# Appendix N

Record of Public Comments and Responses

Appendix N provides responses to the public and agency comments received during the US 97 Bend North Corridor Draft EIS public review and comment period, which occurred July 29, 2011 through September 12, 2011. During the review and comment period, ODOT and FHWA received 166 comments primarily in the form of letters, emails, comment forms, and oral testimony provided at the public hearing. Many comments from agencies and the public had similar themes, such as impacts to the rural residential character of the Hunnell Neighborhood or how the project relates to the City of Bend's proposed urban growth boundary (UGB) expansion. FHWA and ODOT prepared general topic responses to ensure consistency in the information provided in response to these comments. Throughout the Record of Comments, where a comment relates to one of the general topics, in whole or in part, the response to the comment includes a reference to the appropriate topic number and heading. While these general topic responses have been prepared in response to similar themes that were raised in multiple comments, these general topic responses are likely beneficial for a

## Figure 3: East DS1 Scenario Figure 3: East DS1 Scenario NORTH NORTH

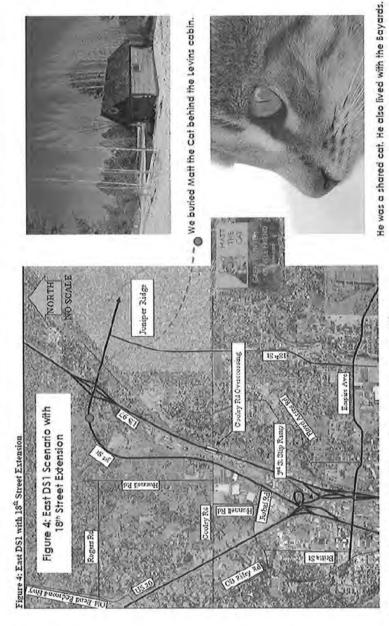
Figure 3 will turn into Figure 4. Juniper Ridge will get its western entrance. 18th Street will connect to 3td Street

ODOT's and FHWA's consideration of comments on the Draft EIS resulted in our agencies identifying the East DS2 Modified Alternative as the Preferred Alternative in the Final EIS. The Preferred Alternative does not include a northern interchange. Under the Preferred Alternative 3rd Street will connect to US 97 at a new signalized intersection south of Deschutes Memorial Gardens and Chapel as shown in Exhibit 2-3 FEIS (Map 7) in the Final EIS.

# Reroute alternative 1

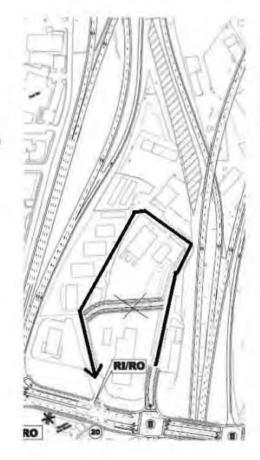
Don't put in the street that is crossed out. Instead reroute traffic all the way around the buildings. This gives each business in this area a "frontage road". This does not take anyone's property.

Thank you for the information about your business use of the storage sheds. We acknowledge your concern about right of way acquisitions associated with the project. A local connector road is required for internal circulation between Nels Anderson Road and Cady Way and to facilitate movement of emergency service vehicles as shown in Exhibit 2-3 FEIS (Map 2). Please also see Topic 7 – Empire Avenue north industrial area.

# Reroute alternative 2

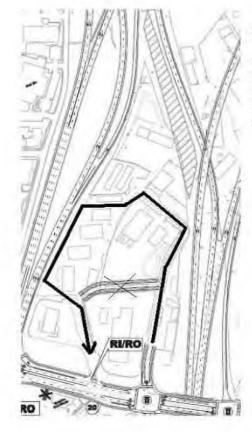
Don't build through our property and use the existing trafic lane already in use. This is what trucks do currently.

# Reroute alternative 3

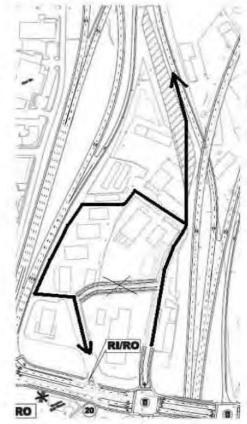
Don't build through our property, and instead reroute traffic around the front of the East side businesses. This gives those buildings additional exposure.

## Reroute alternative 4

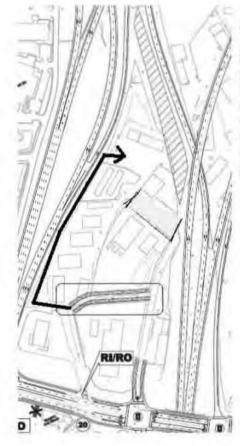
Don't build the road through our property and instead combine a frontage road with an onramp. This also helps with traffic around the businesses.

# Reroute alternative 5

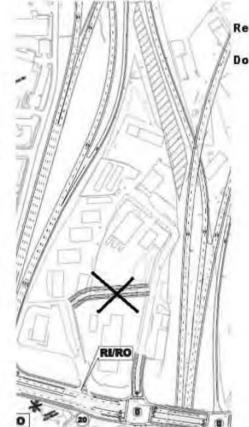
Keep the road going through our property, but then give us the highlighted portion of Cady way. We will fence it off and utilize it for storage. Place a frontage road in front of the businesses on the East side. This also gives better access to Pape.

004 Cont.

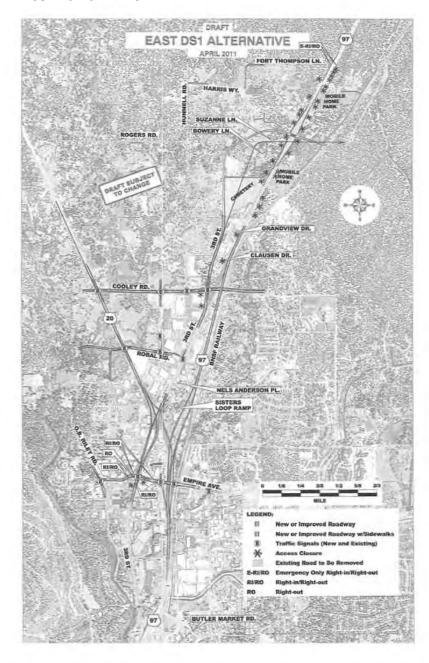
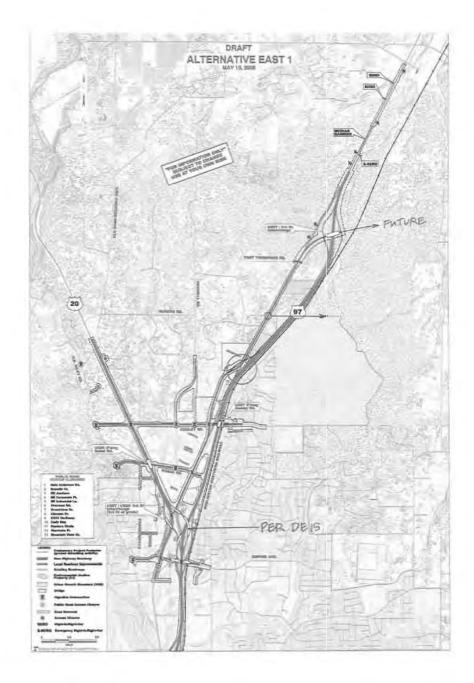
- Add a multi-lane roundabout or signalized intersection on Third Street at the alignment of Rogers Road/north boundary of Juniper Ridge. Extend a 5-lane arterial due east to the BNSF/US-97 rightsof-way. It is my view that a bridge over these facilities should be a North Corridor cost. Juniper Ridge can assume responsibility for the facility from there, running to the east.
- 4. Because the southbound exit off of US-97 is considerably north of Cooley Road, add a flyover southbound exit ramp from US-97 to Third Street at the point where the two alignments come closest together – shown on the attached map as circled in red. This should resolve the legitimate concerns of Cascade Village about closerproximity access to their project.

This modified East 1 proposal remedies every component of opposition that I'm currently aware of.
